**OVERLAY DISTRICT
SITE PLAN APPLICATION**

Date 8/26/91NAME OF PROPOSED DEVELOPMENT VIDEO VILLAGE INC.

RE: Site Plan for the Video Village Development

Agenda Item: P&Z 91-30-SP/FP - Discuss and Consider Recommending Approval of a Site Plan and Final Plat for Video Village

FINAL PLAT
Lot 3, Block 1
Steger Retail Addition
City of Rockwall, Rockwall County, Texas

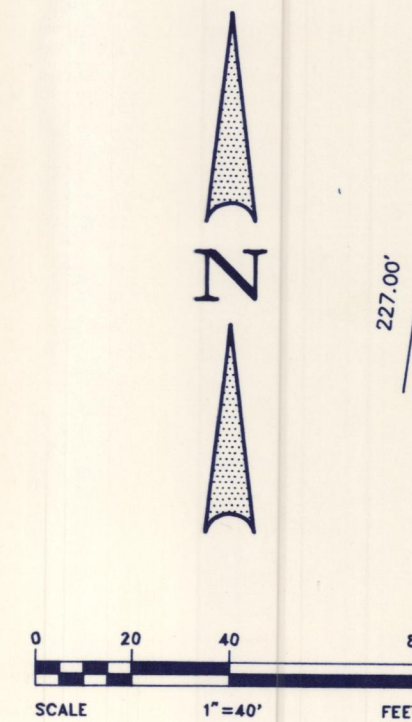
1. need application ~~with fee~~

2. need Road name

3. need 10' easement or 60' collar

4. need to redo opposite utility easement

4. Cross access easements need to be placed on
the plat on the drive in front of the
store and on the driveway to the rear

SITE PLAN

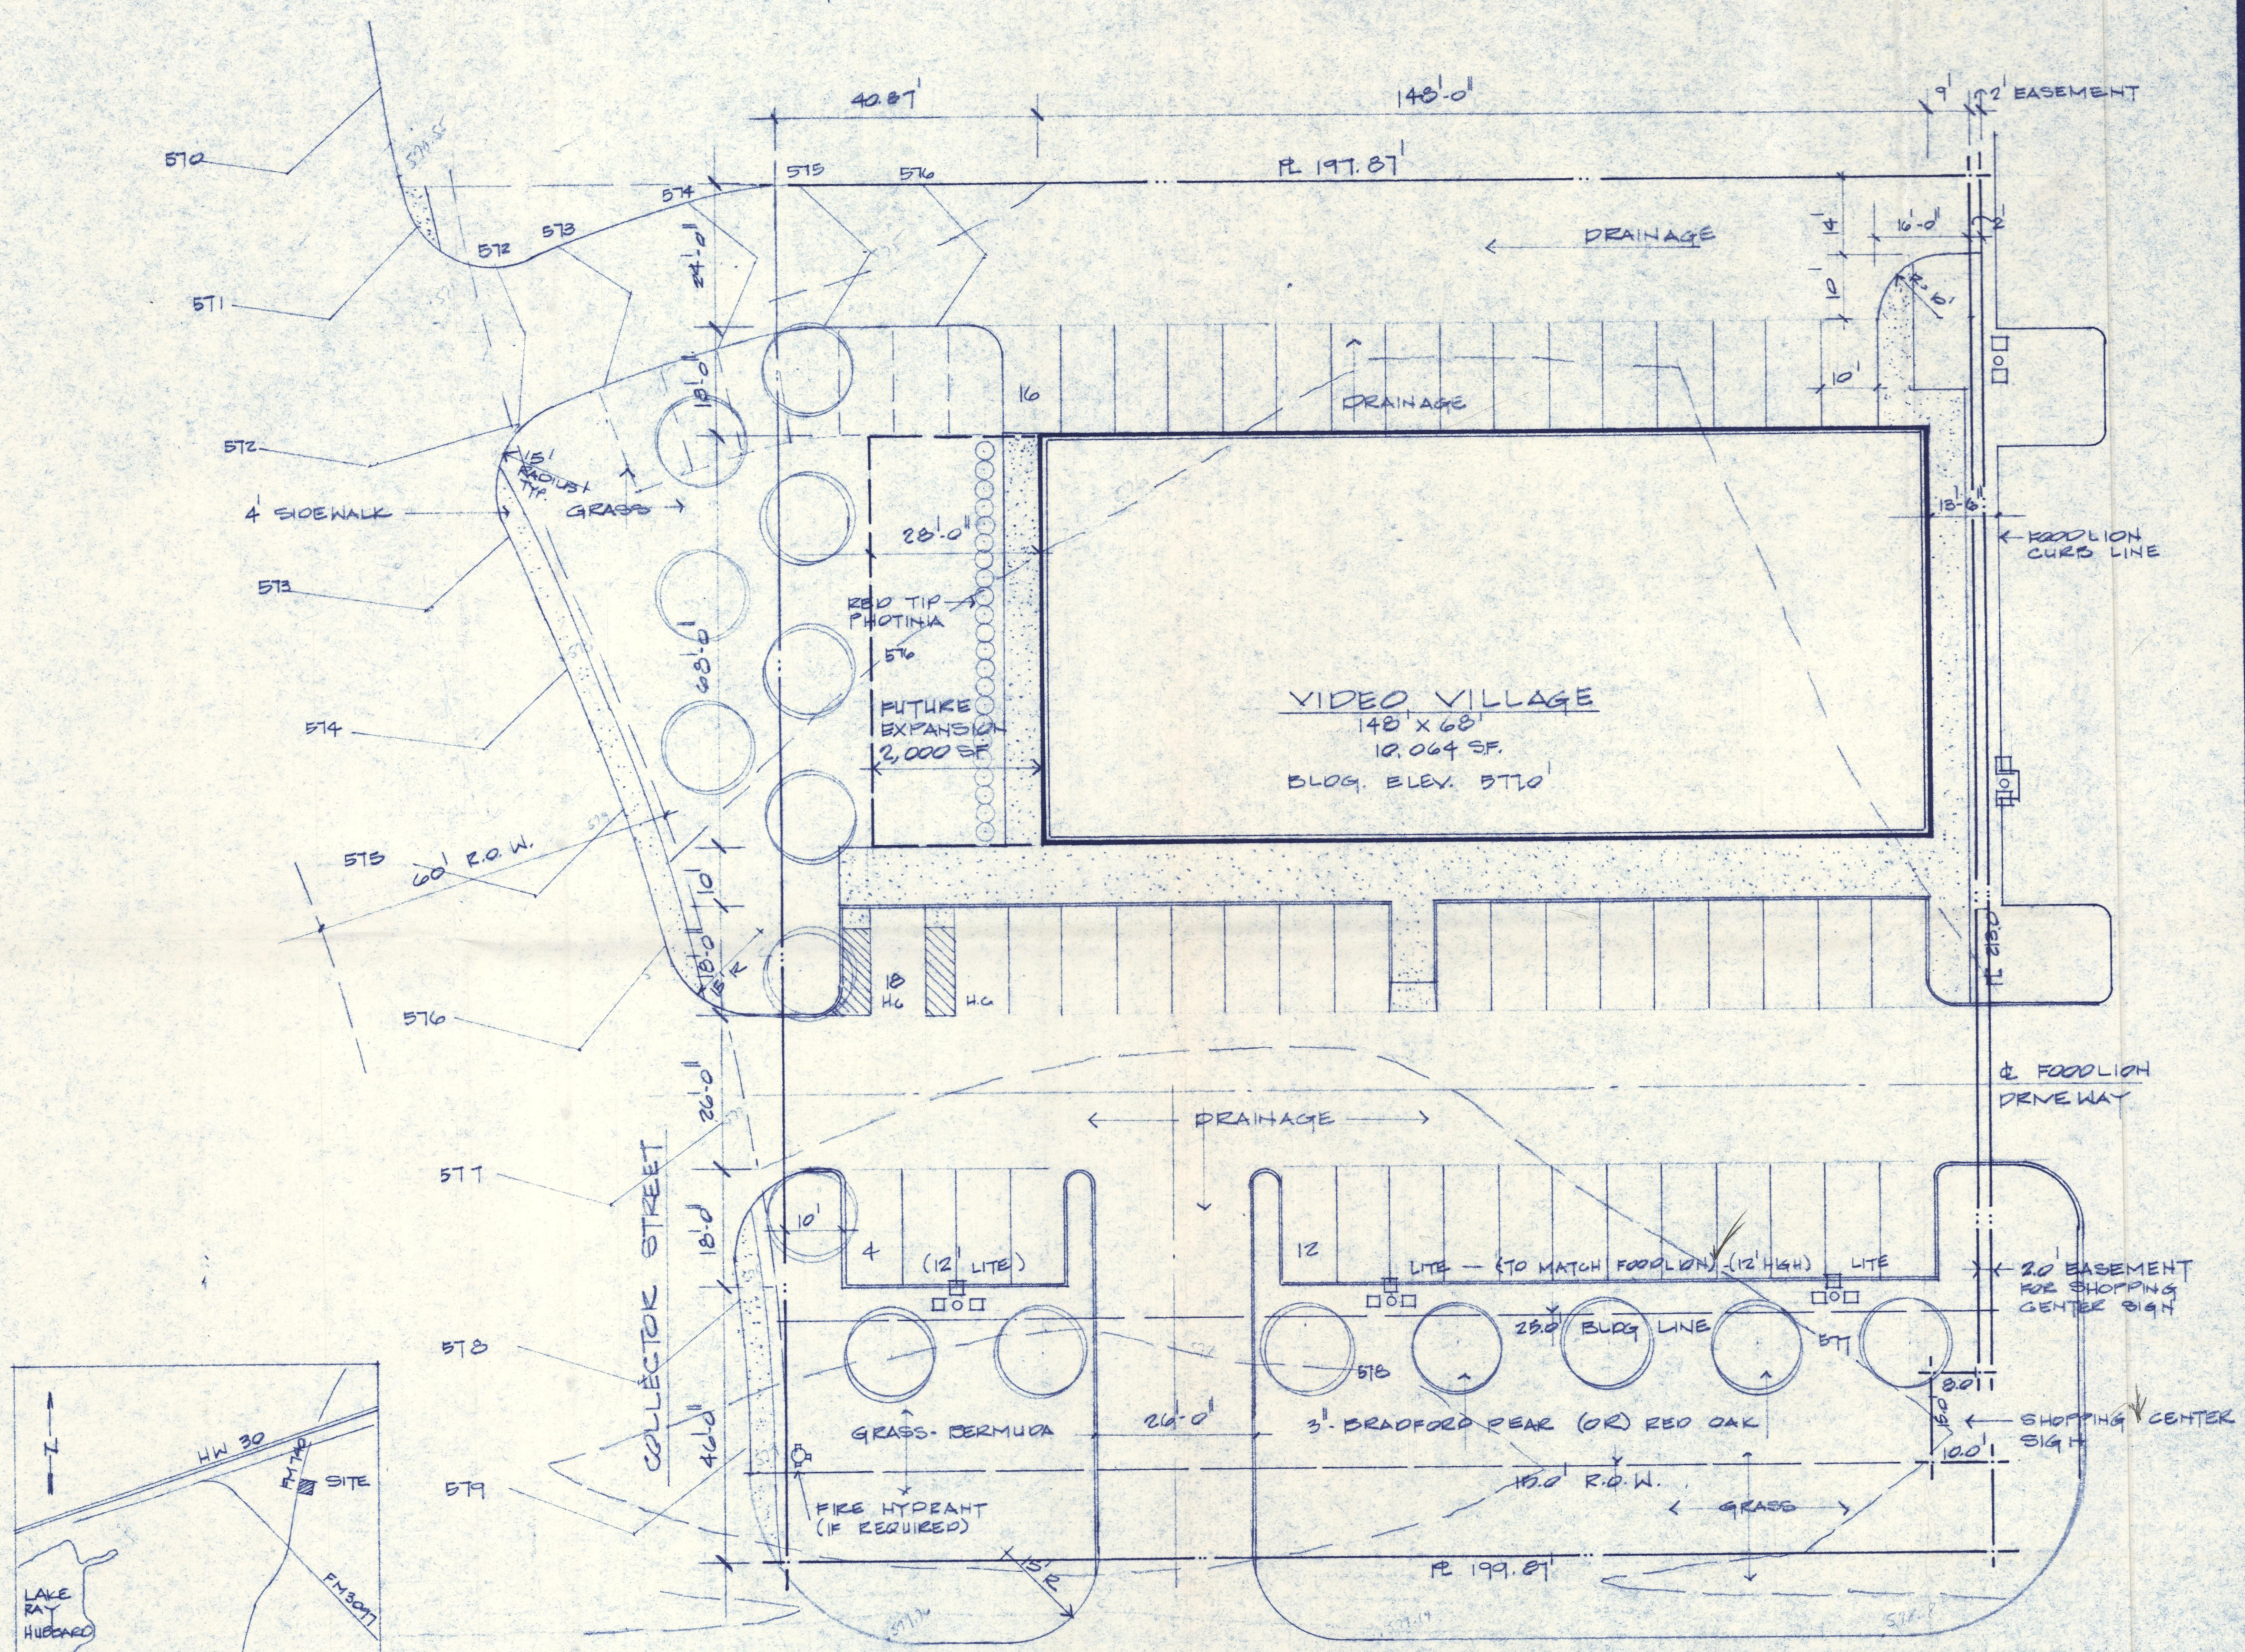
We have received a request from Al Welch for a site plan approval for a proposed site for a new Video Village to be located on FM-740. The site is to be located north of the Food Lion site and will be on the corner of FM-740 and the collector street that will traverse the Steger site and tie into a future 6-lane off of FM-3097. The site plan is attached and our comments are as follows:

1. The site shows one entrance off of FM-740 and two entrances off of the new collector. We have indicated to the applicant that the entrance off of FM-740 does not meet the 200 foot separation that we normally look for, although this is a separate site from Food Lion. The first entrance off of the collector is 60 feet from the future paving line of FM-740. The applicant had originally proposed a 30 foot distance which concerned staff. We had hoped for a 100 foot setback. We plan to have a recommendation from John Reglin, our traffic planner, by the meeting to address this.

3. The site plan shows a future expansion of 2,000 sq. ft. Parking is not provided for this additional sq. footage and we have asked the applicant to address this issue. The 740 drive would provide several parking spaces if it were removed. We do question the need for this entrance. If the entrance is approved it needs to be moved at least 100 feet from the intersection.

WEST ELEVATION
SCALE 1/8" = 1'-0"

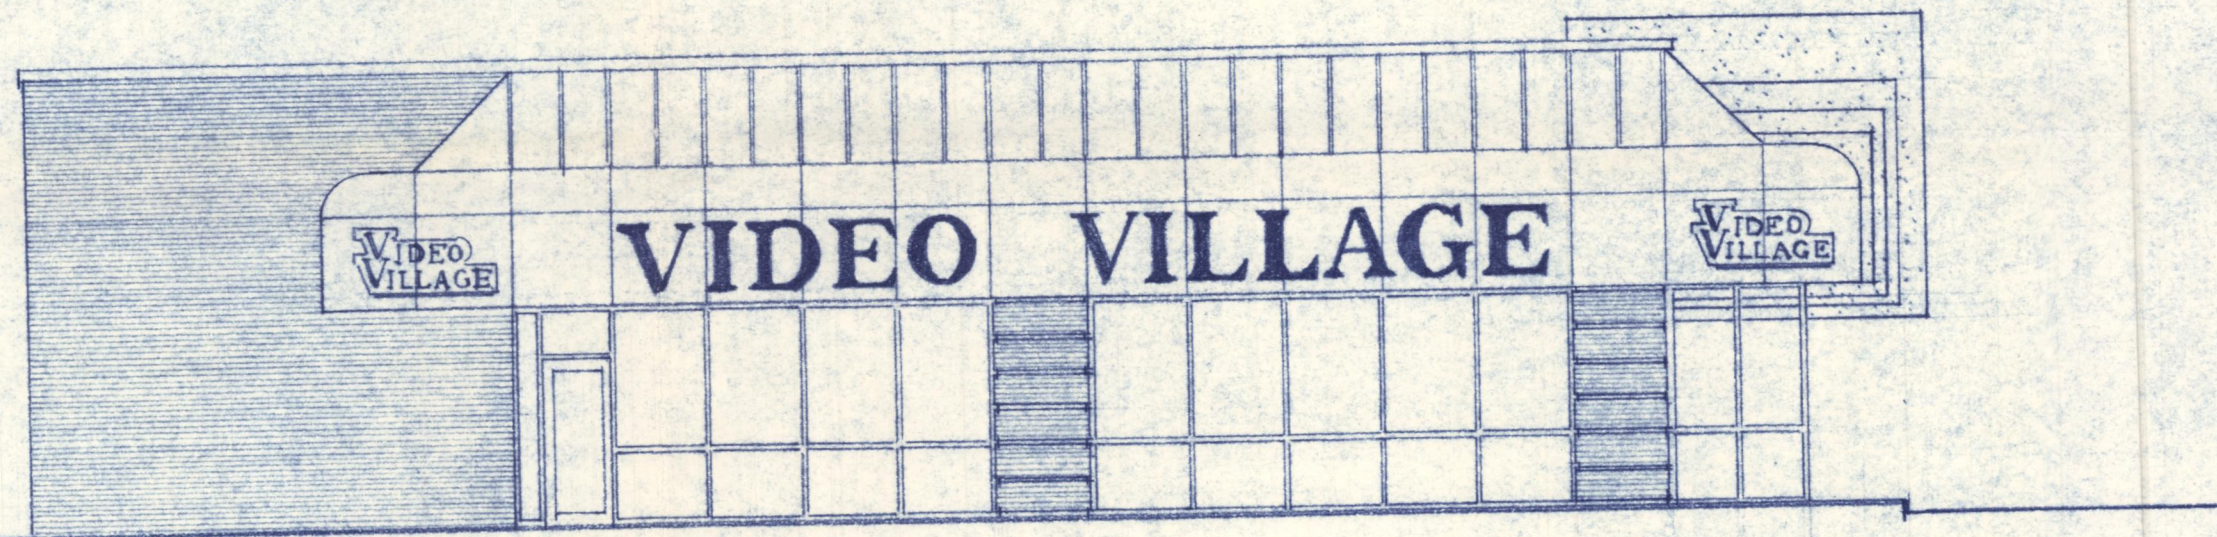
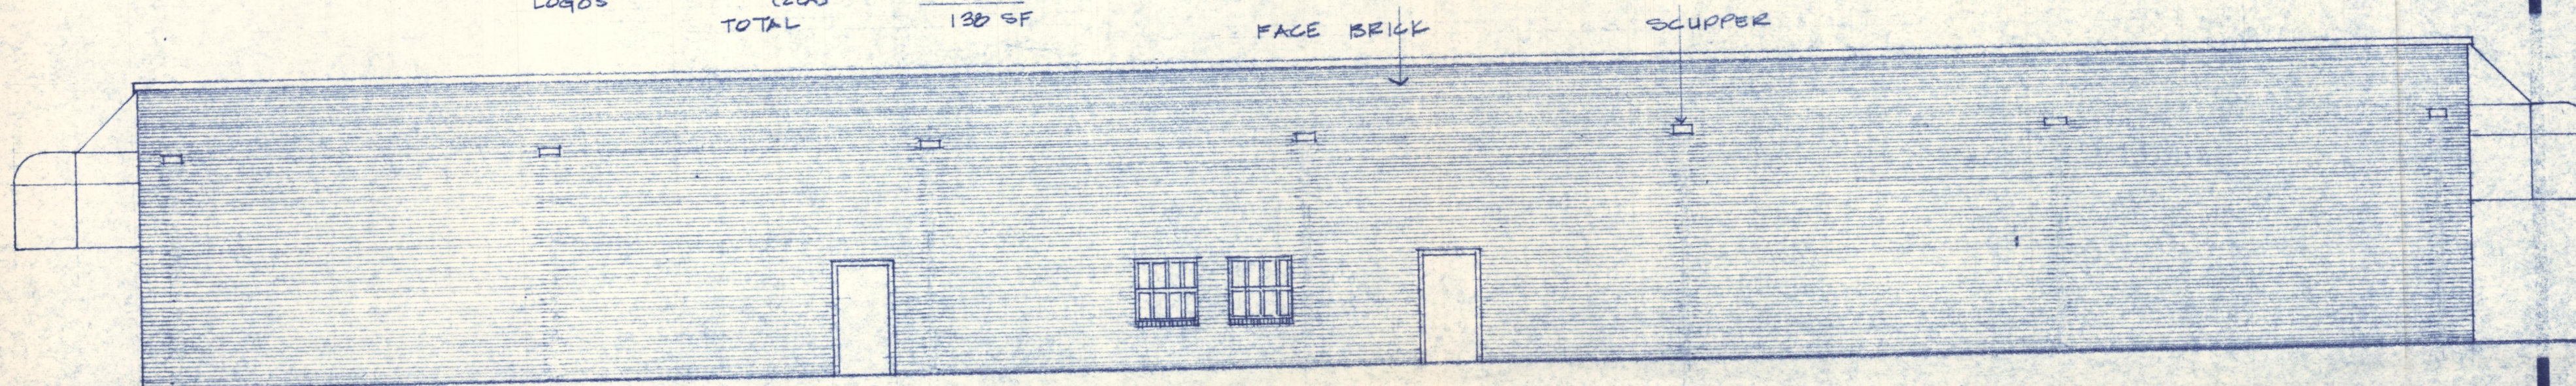
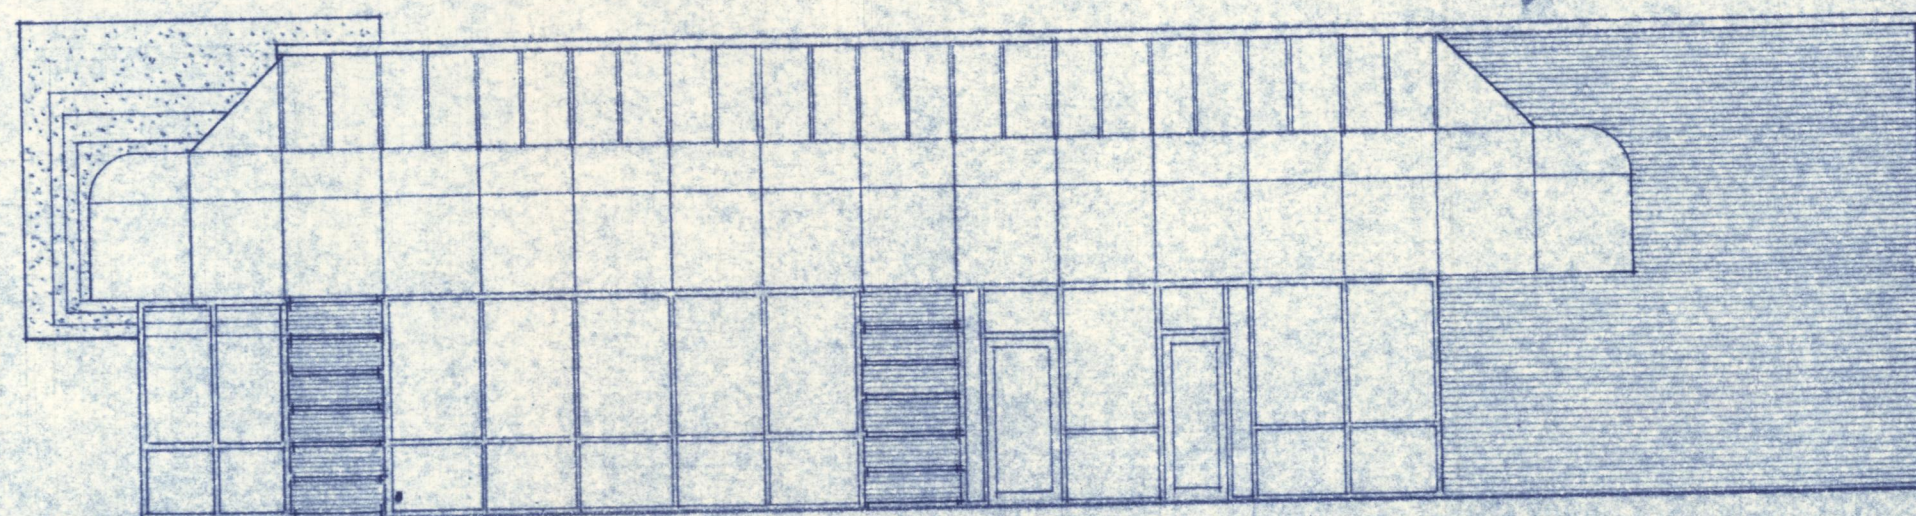
1. DUMPSTER LOCATION ? & SCREEN
2. 12.87' FRONT YARD Set Back OK?
(WHEN COLLECTOR ST. IS INSTALLED)
3. REAR LIGHTING *Security Lights*
4. UGLY REAR! NEEDS TO BE BROKEN UP
BY: ① BRICK DETAIL FROM FRONT
② CANVAS CANOPY'S ON DOORS OR WINDOW
③ GRAPHICS
SOME DAY THE BLDG WILL BE VIEWED FROM
ALL SIDES
5. GROUP TREES IN MORE NATURAL GROUPINGS
6. IS THERE A FREE STANDING SIGN? OR IS
BUILDING GRAPHICS SUFFICIENT?
7. OMIT 26'-0" DRIVE - TO CLOSE TO COLLECT
STREET (RECOMMENDATION) BETTER
TRAFFIC CONTROL ON 740
8. ROOF TOP H.V.A.C. UNITS - SCREENED!!?
OR MECH. EQUIPMENT YARDS?
9. PG. 3. ANY LUMINAIRES IN SOFFIT LIGHTING
THE WALKWAY

1. The Architectural Review Board has recommended that the back of the building be enhanced with brick work and/or canopies. The applicant will address this item at the meeting on Thursday. They have also recommended that the applicant provide information to ensure that the AC units will not be visible from the street. There is a parapet wall of approximately 4 feet all around the building and the applicant has indicated that this will not be a problem. They have also recommended that the trees be more naturally planted in the street buffer.

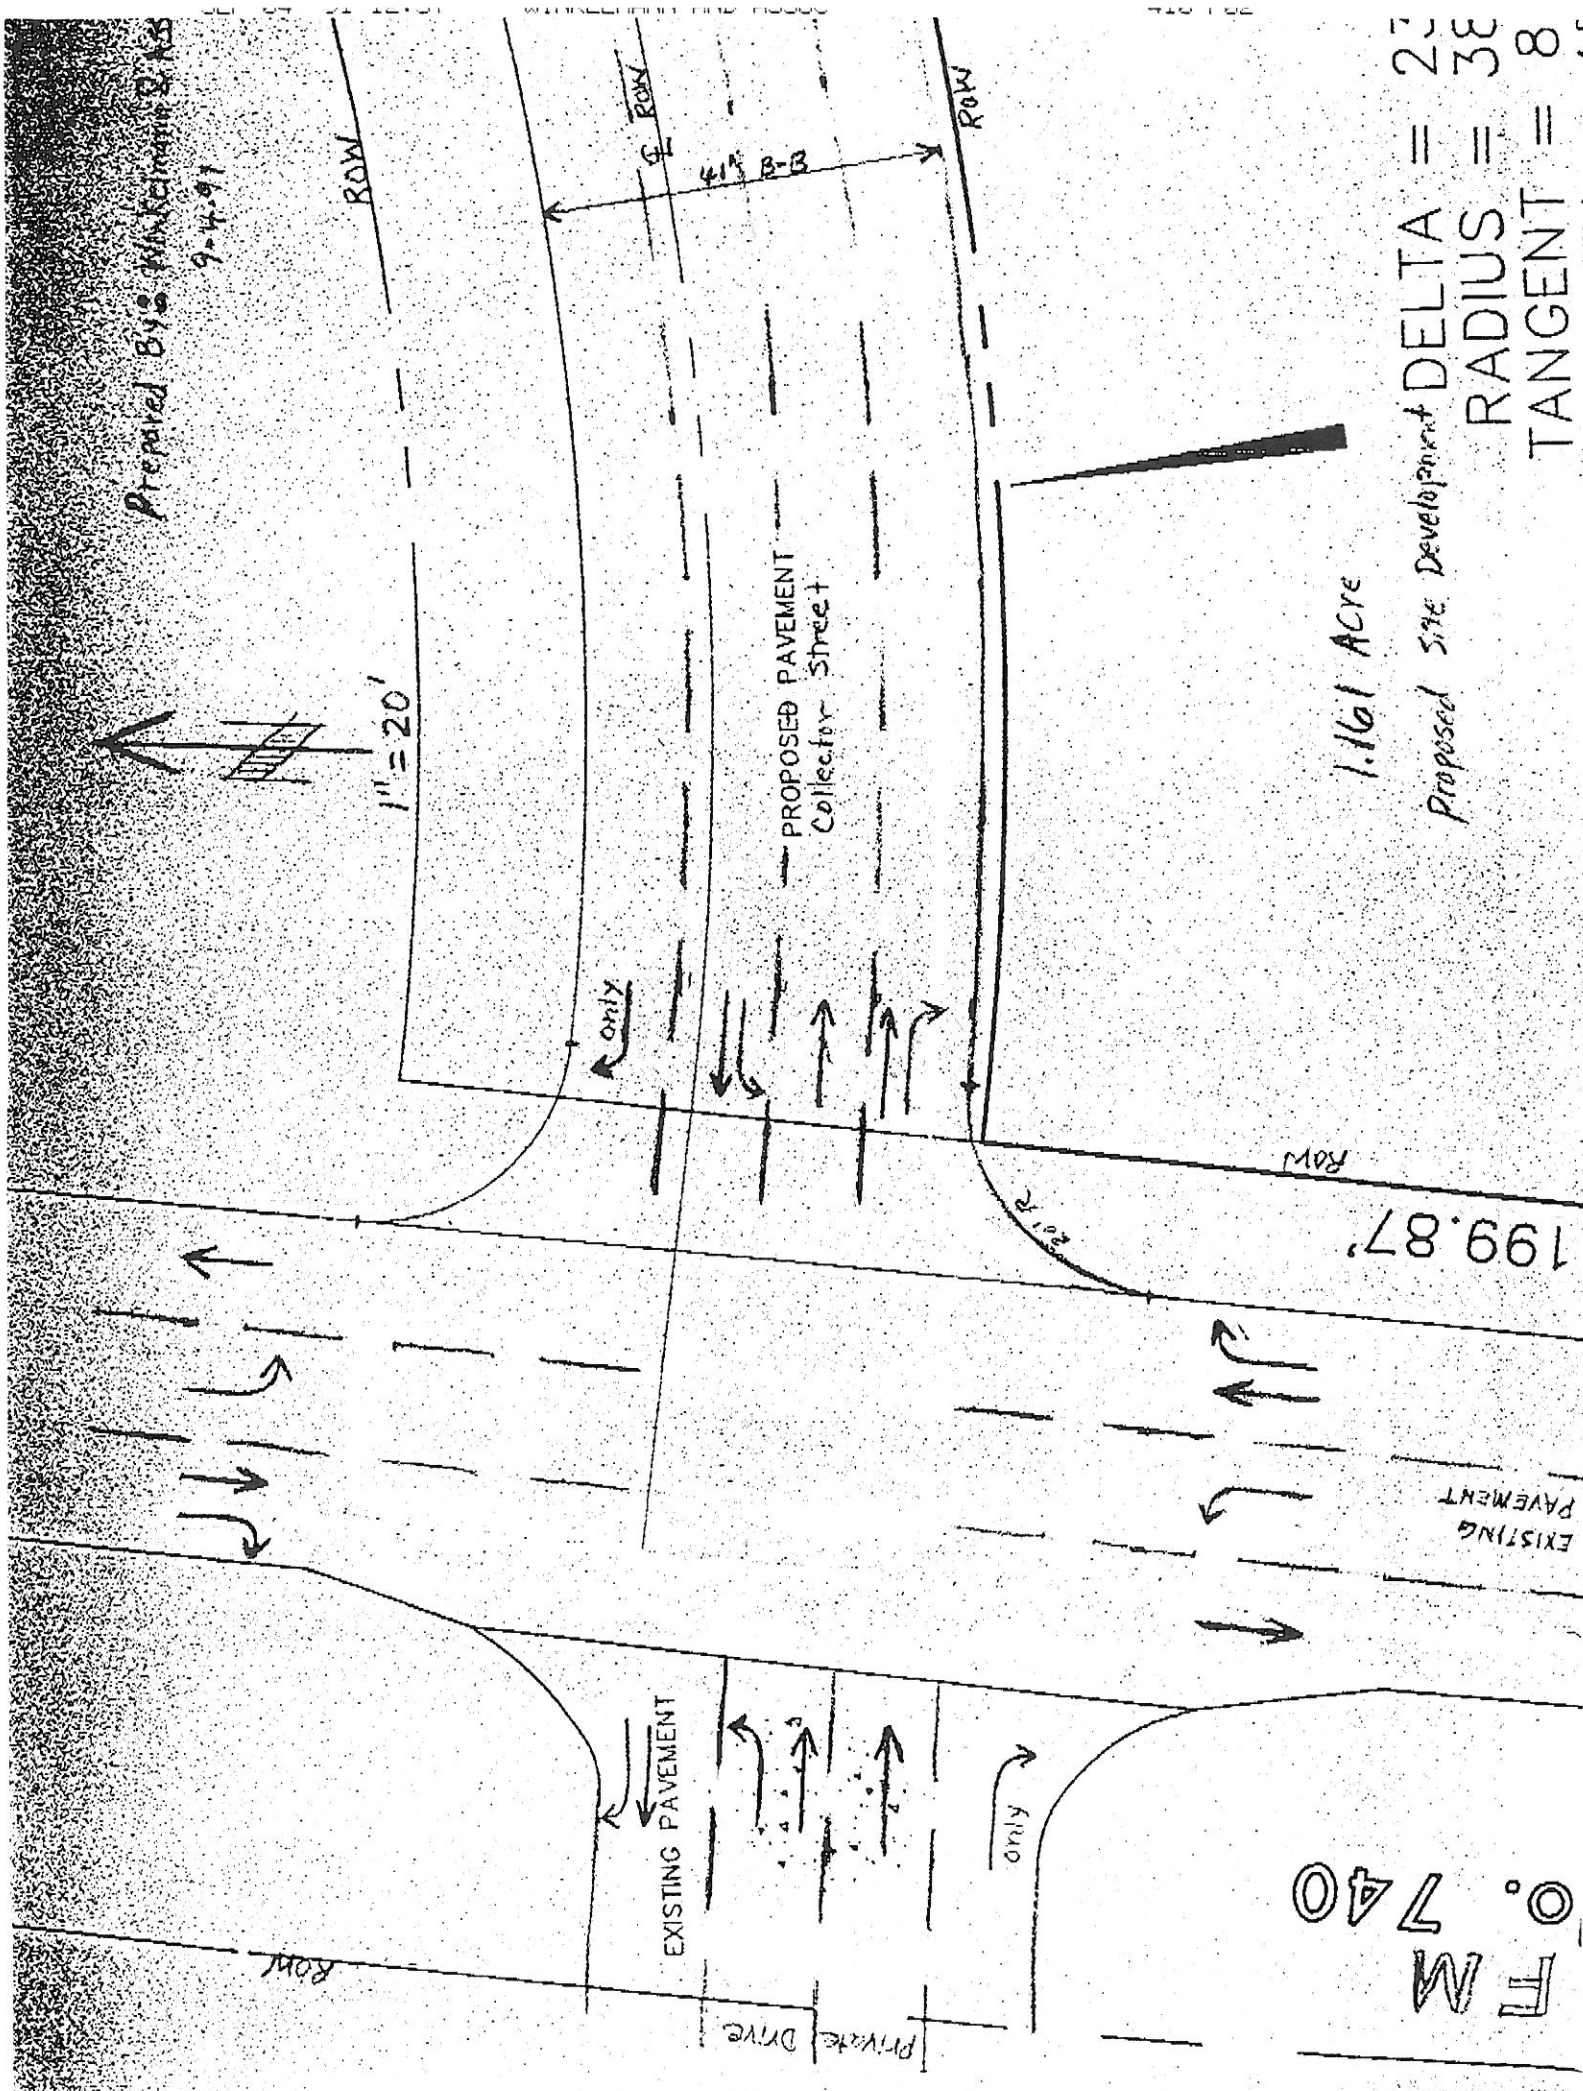
✓ need to show radius on steel enticement 15'
